**VOLUME 2 - APPENDIX A
FINAL APPROVED PLAN**

**GILL CREEK REMEDIATION
PROJECT
FINAL REPORT**

Du Pont and Olin respectfully submit eight copies of "Gill Creek Remediation, Construction Plans and Specifications." Per the Order on Consent, we are presenting this package for NYSDEC review and approval. In order to meet the construction schedule which is planned to begin in mid-June, we request a rapid review.

FIG. 7 (REVISED)

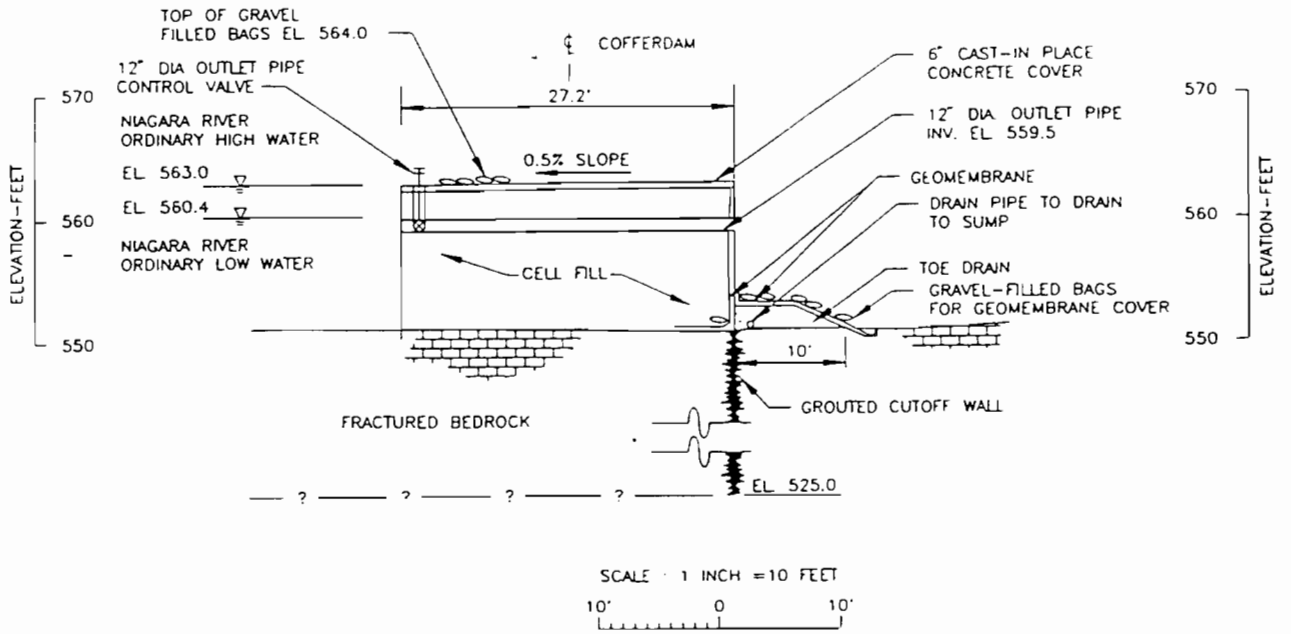
Enclosed for your review is a revised Section E which describes the construction and removal of a cellular cofferdam. Figures 9 and 10 (revised) illustrate the plan view, profile and typical section of the cellular cofferdam. The crest and spillway elevations will be the same as the rockfill and earthfill design. The cellular cofferdam will, however, require considerably less fill material to be placed in the Niagara River; approximately 4,000 cubic yards versus 13,000 cubic yards for the rockfill and earthfill design. Fewer truck trips will be necessary to transport materials to the site. The

The cellular cofferdam will be constructed in the Niagara River to retain the river water from Gill Creek as shown in Figure 7 (revised). The crest of the dam will be at elevation 565.5 feet or about 2.5 feet above the ordinary high water (OHW) level of the Niagara River as defined by the U.S. Army Corps of Engineers (El. 563.0 feet). The cofferdam will be constructed using sheet piles, geomembrane, and earthfill. The earthfill will consist of clayey sands or clayey gravels with approximately 20% fines (percent passing No. 200 sieve) and maximum size of 3 inches. The crest of the dam will be covered with a layer of soil cement approximately 6 inches thick. The interior of the creekside face of the cellular cofferdam will be lined with a geomembrane to protect the earthfill inside the sheet piling from contamination due to the remediation activities and also to divert any seepage to a drain at the toe of the cofferdam. The drain system, consisting of a slotted 6-inch PVC pipe embedded in clean sands and gravels, will collect

As shown on Figure 7 (revised), the cellular cofferdam will extend into the bank of the Niagara River and tie-in to a sheet pile wall constructed along the bank of the Niagara River. The sheet pile walls along the river bank will extend to the wing walls of the RMP. The sheet pile walls will be constructed by excavating a trench, backfilling the trench with earthfill material and driving sheet piles to form a cutoff wall. Boreholes will then be drilled adjacent to the sheet pile wall to allow grouting to be performed in the upper 30 feet of bedrock.

FIG. 9 (REVISED)

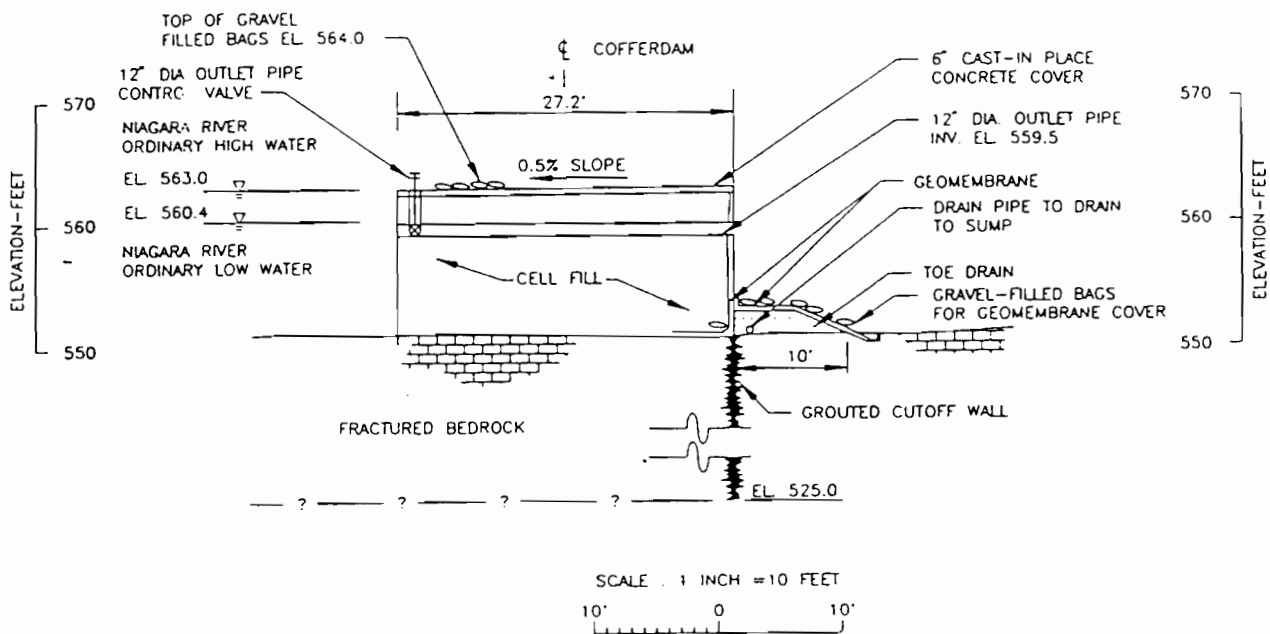
Enclosed for your review is a revised Section 4.7.3 which describes the construction and removal of a cellular cofferdam. Figures 9 and 10 (revised) illustrate the plan view, profile and typical section of the cellular cofferdam. The crest and spillway elevations will be the same as the rockfill and earthfill design. The cellular cofferdam will, however, require considerably less fill material to be placed in the Niagara River; approximately 3,600 cubic yards below the ordinary high water elevation versus 12,000 cubic yards for the rockfill and earthfill design. (Refer to the attached revised Table

The cellular cofferdam will be constructed in the Niagara River to retain the river water from Gill Creek as shown in Figure 9 (revised). The crest of the dam will be at elevation 565.5 feet or about 2.5 feet above the ordinary high water (OHW) level of the Niagara River as defined by the U.S. Army Corps of Engineers (El. 563.0 feet). The cofferdam will be constructed using sheet piles, geomembrane, and earthfill. The earthfill will consist of clayey sands or clayey gravels with approximately 20% fines (percent passing No. 200 sieve) and maximum size of 3 inches. The crest of the dam will be covered with a layer of soil cement approximately 6 inches thick. The interior of the creekside face of the cellular cofferdam will be lined with a geomembrane to protect the earthfill inside the sheet piling from contamination due to the remediation activities and also to divert any seepage to a drain at the toe of the cofferdam. The drain system, consisting of a slotted 6-inch PVC pipe embedded in clean sands and gravels, will collect seepage and route it to a sump from which it will be pumped back into the Niagara River. The bedrock below the cellular cofferdam will be grouted to minimize foundation seepage. The earthfill and drain material for cofferdam construction will be obtained from off-site borrow sources.

As shown on Figure 9 (revised), the cellular cofferdam will extend into the bank of the Niagara River and tie-in to a sheet pile wall constructed along the bank of the Niagara River. The sheet pile walls along the river bank will extend to the wing walls of the RMP. The sheet pile walls will be constructed by excavating a trench, backfilling the trench with earthfill material and driving sheet piles to form a cutoff wall. Boreholes

TOE DRAIN MODIFICATION	GILL CREEK REMEDIATION E.I. DUPONT CORP SEVENSON ENVIRONMENTAL SERVICES	DRAWING TD-1	DATE: 2/29/92 SCALE: NONE DRAWN BY: RR
------------------------	---	-----------------	--

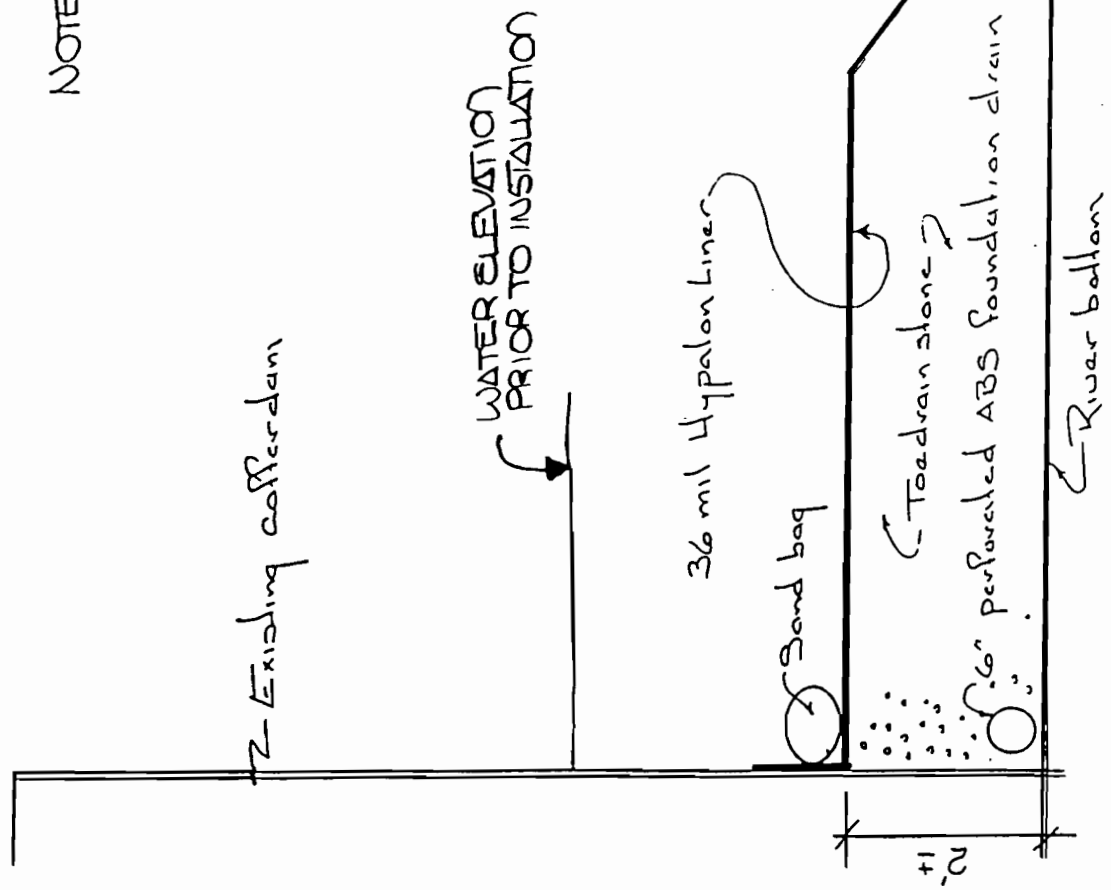
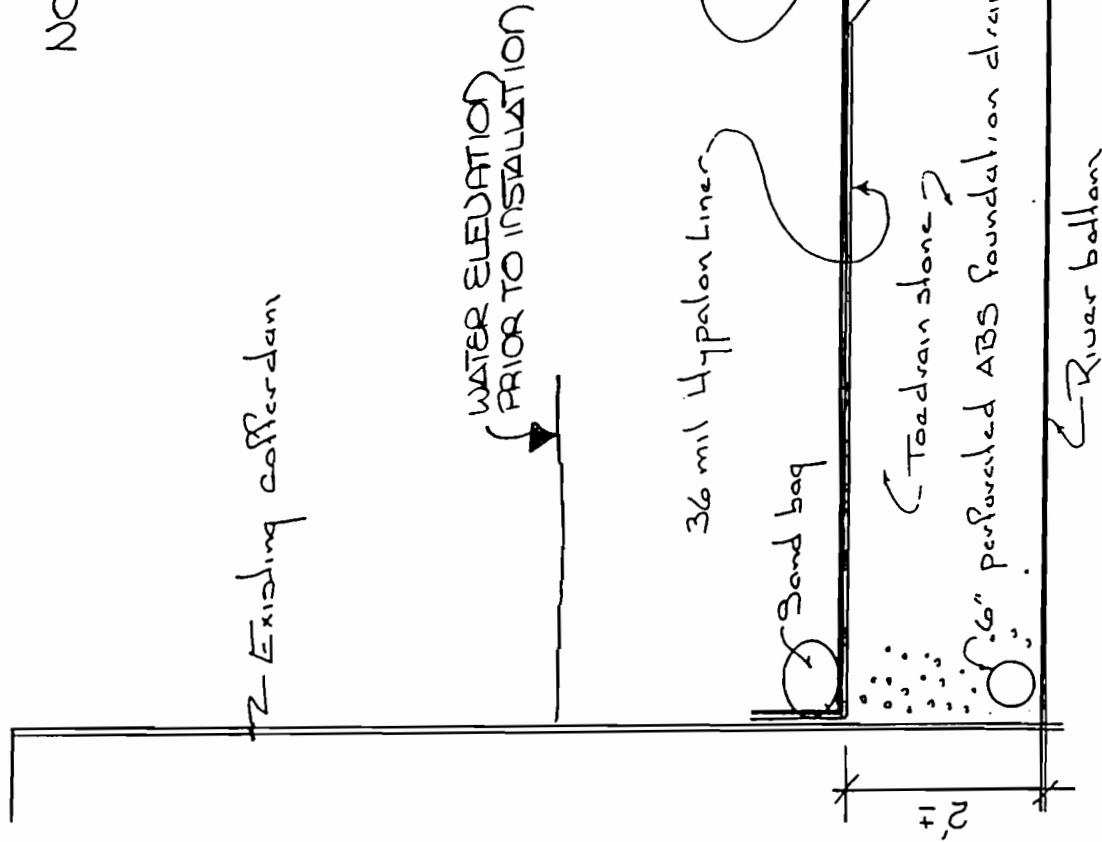
We propose to leave the cobblebars in place for now, and add a "plug" of clay to extend and complete the barrier across the mouth of the creek. The cobblebars appear to be impermeable at the bases. The clay plug will be about 80 cu. yds and 2 feet tall. The intent of the cobblebar-plug barrier is to isolate the area north of the cobblebars so that the contaminated sediments north of them are contained and excavation can begin, and to enhance water management. Once the plug is installed we will be able to proceed with sediment removal north of the cobblebars and we will also be able to proceed with installation of the toe drain.

Because of the upwelling from the riverbed there is more inflowing water than expected. Additional grouting will probably not be adequate to reduce the inflows to a more manageable level. We are proposing that we extend the toe drain to surround the upwelling, and return the upwelling water to the river along with the rest of the toe drain water.
